SSES-FSAR

QUESTION 312.1

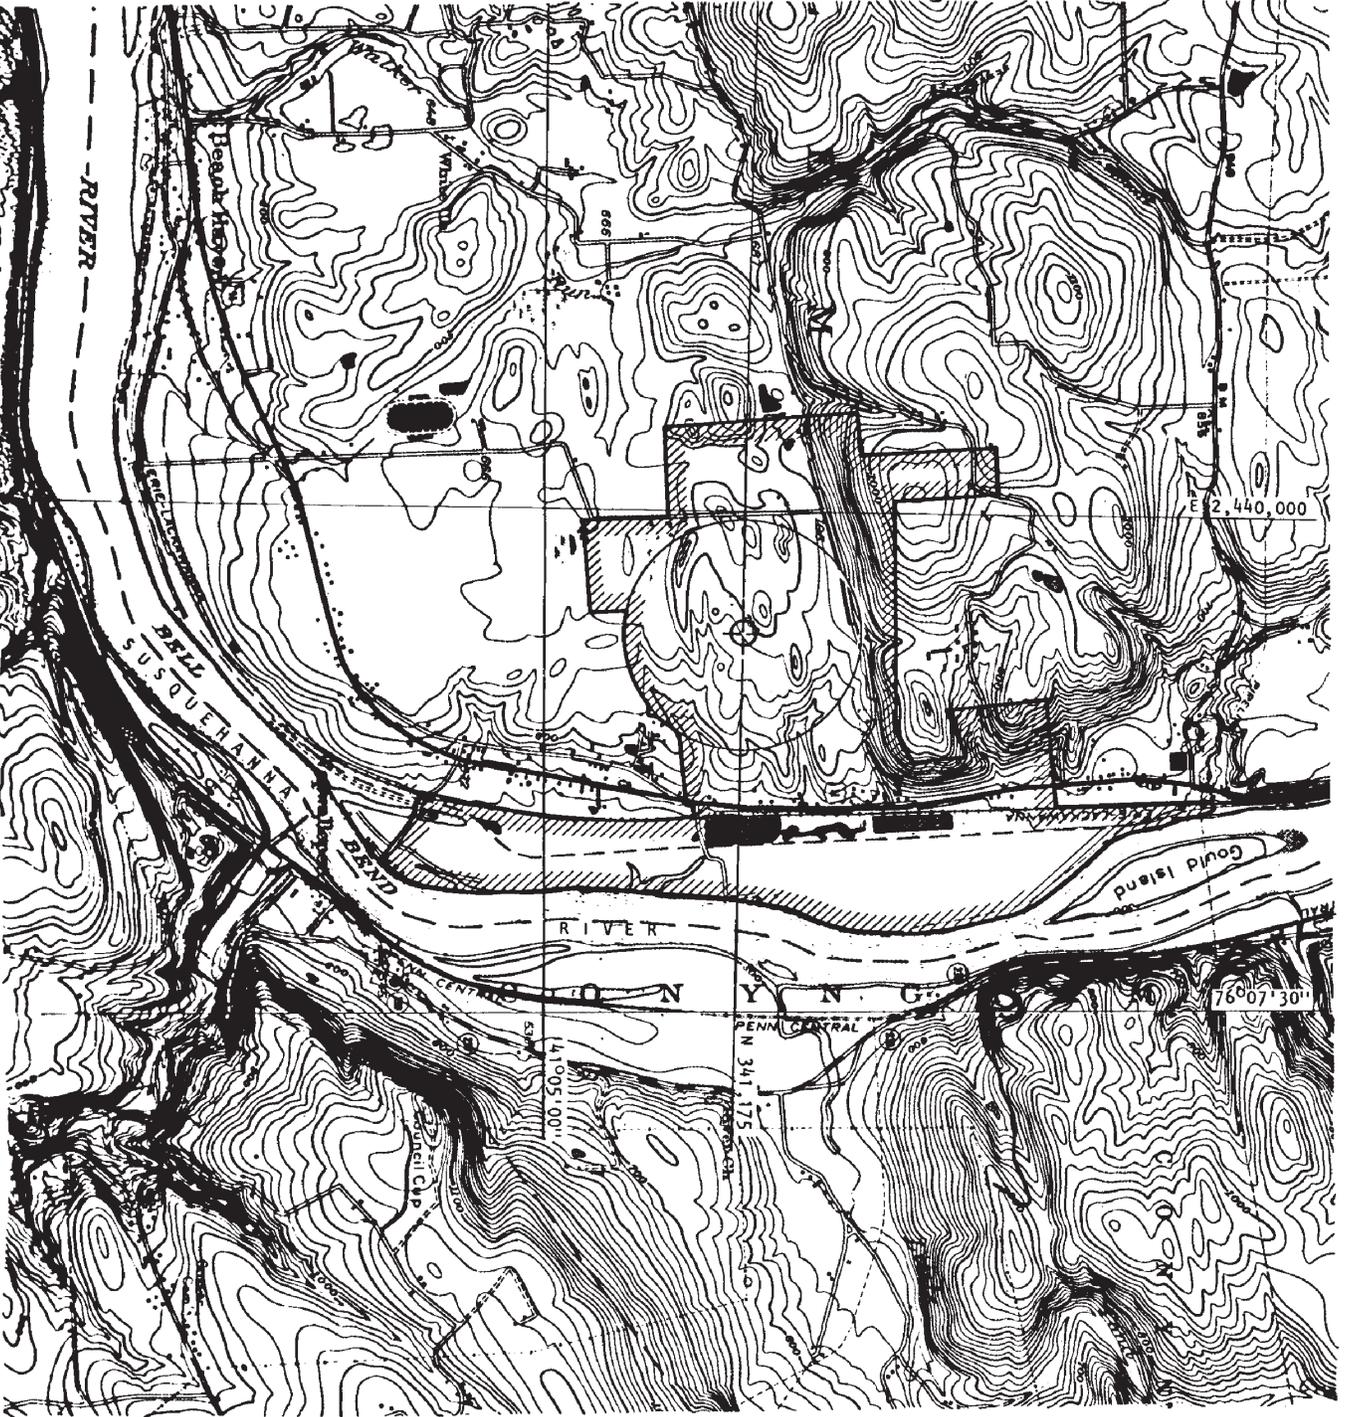
None of the maps in the FSAR clearly show the exclusion area boundary. Provide a full scale section of the USGS map of the Berwick, PA quadrangle which clearly shows the exclusion area as well as the plant boundary. (FSAR Figure 2.1-1 is too small to provide sufficient detail.)

See the SSES Emergency Plan or the Technical Specifications for a depiction of the exclusion area.
